Access Compliance Report

Public Rights-of-Way

Intersection ID: 53775	Main Street: STRAWBERRY_FIELDS_LN	Cross Street: CHAPECLANE_RD	Location: E
ADA ID: 93AD0BFD72DD	Ramp Type: Perp	Initial Pass/Fail: Fail	Overall Compliance: No
Severity Score: 12.5			
Codes/Mitigation Info/Possible Solution		Field Measurements/Component Compliance

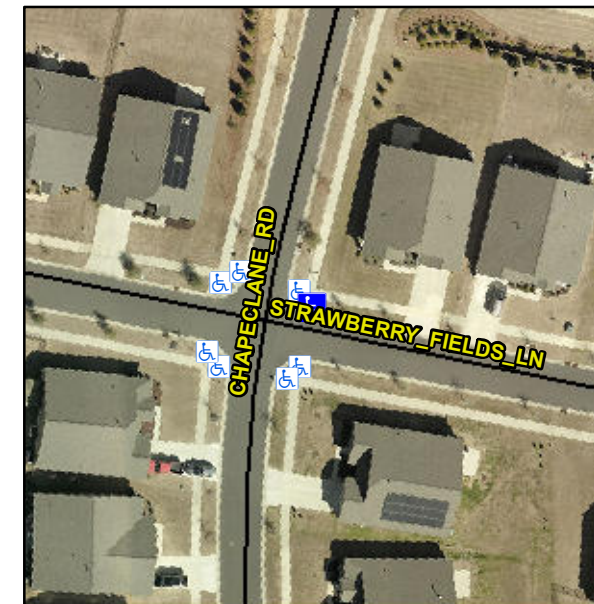
Not Found, R304.5.3

Compliance	Description	Data	Compliance	Description	Data
N/A	Ramp Length (in)	90.0	Yes	Ramp Slope (%)	7.7
Yes	Ramp Width (in)	48.0	No	Ramp XSlope (%)	5.2
N/A	Flare Type LT	N/A	N/A	Flare Type RT	N/A
N/A	Flare Slope LT (%)	N/A	N/A	Flare Slope RT (%)	N/A
N/A	Flare Traversable LT?	N/A	N/A	Flare Traversable RT?	N/A
N/A	Landing Length (in)	N/A	N/A	DWS Provided?	N/A
N/A	Landing Width (in)	N/A	N/A	DWS Contrast?	N/A
N/A	Landing Slope (%)	N/A	N/A	DWS Length (in)	N/A
N/A	Landing X Slope (%)	N/A	N/A	DWS Full Width?	N/A
N/A	Landing Curb? (Y/N)	N/A	N/A	DWS Offset (in)	N/A
N/A	Shared Landing?	N/A			
N/A	Gutter Ponding?	N/A	N/A	Gutter Slope (%)	N/A
N/A	Gutter Lip Ht (in)	N/A	N/A	Gutter X Slope (%)	N/A
N/A	Painted X Walk1?	No	N/A	Painted X Walk2?	N/A
	X Walk 1 Direction	To SW		X Walk 2 Direction	N/A
N/A	X Walk 1 Width (in)	N/A	N/A	X Walk 2 Width (in)	N/A
	X Walk 1 Slope (%)	2.2		X Walk 2 Slope (%)	N/A
	X Walk 1 X Slope (%)	1.2		X Walk 2 X Slope (%)	N/A

Remove & Replace Entire Ramp.
